# CITY OF ALBUQUERQUE

**RE: Circle K – 9610 Eagle Ranch Rd. NW**  
**Temporary Certificate of Occupancy**  
**Engineer's Certification Date: 06/24/2025**  
**Engineer's Stamp Date: 12/22/23**  
**Hydrology File: C13D028**  
**Case # HYDR-2025-00224**

SE POND PROFILE  
SCALE: (H) 1" = 10' (V) 1" = 5'  
START STA: 1+00.00, END STA: 2+11.76

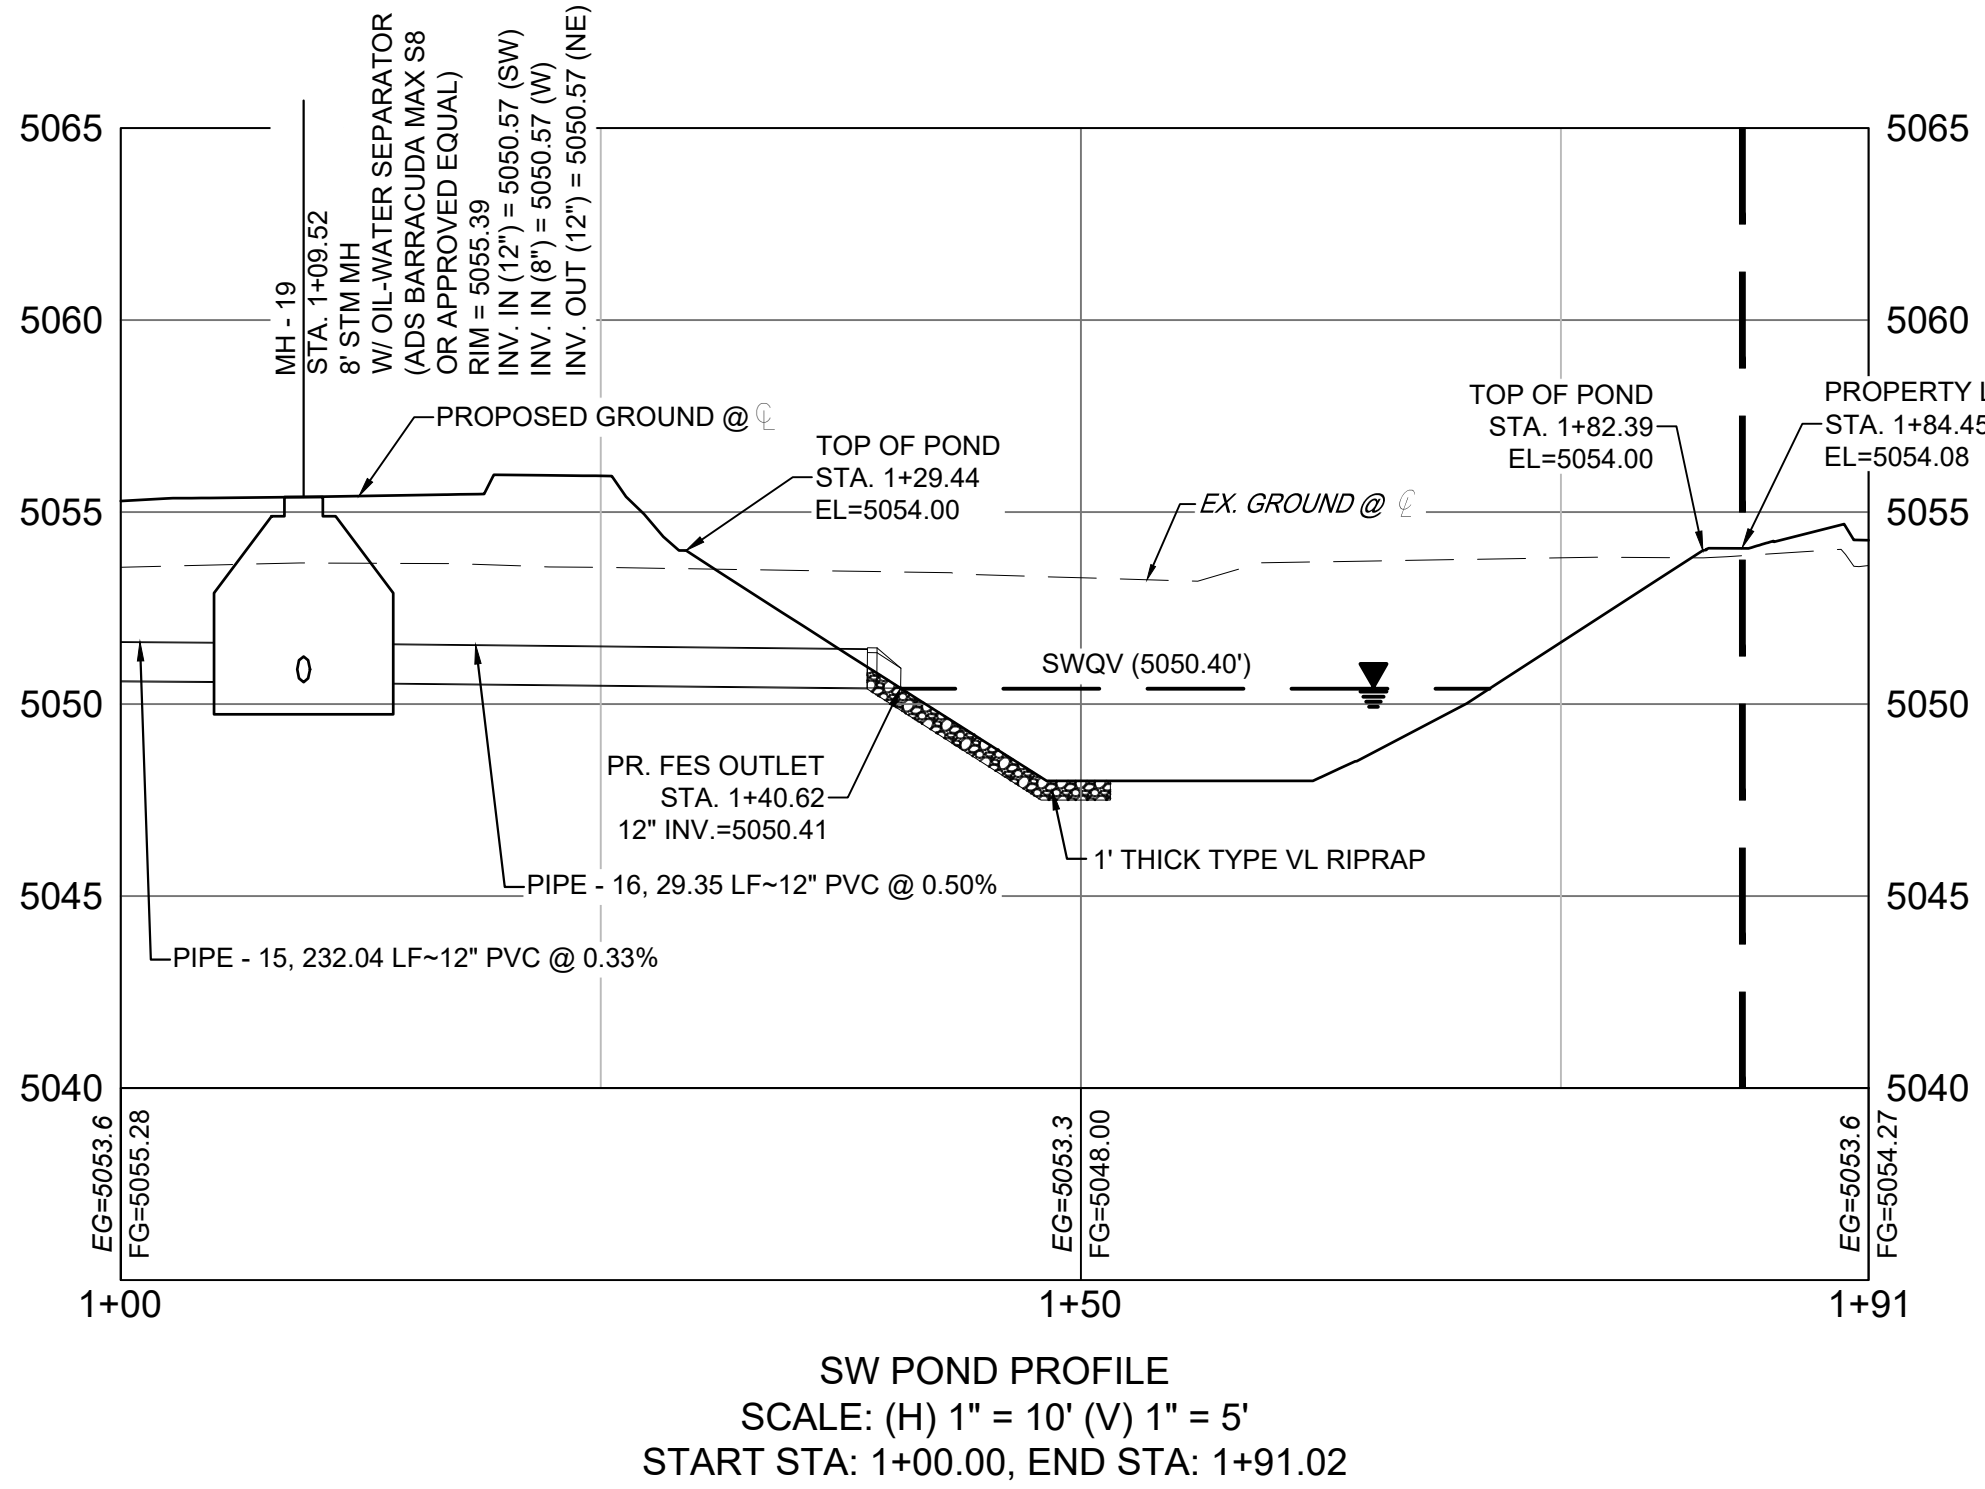
1. Complete the slope stabilization and erosion control needed for the east side of the lot.
2. Please provide the Drainage Covenant with Exhibit A for the stormwater quality pond per Article 6-15(C) of the DPM prior to Permanent Release of Occupancy. Please submit the original copies along with the **\$ 25.00** recording fee check made payable to Bernalillo County to Hydrology. In order to submit the DC, you will need to apply in ABQ-PLAN for a Covenant and upload the Drainage Covenant and Exhibit A (separate attachments). Then the originals and the filing fee are turned in to Hydrology for processing.
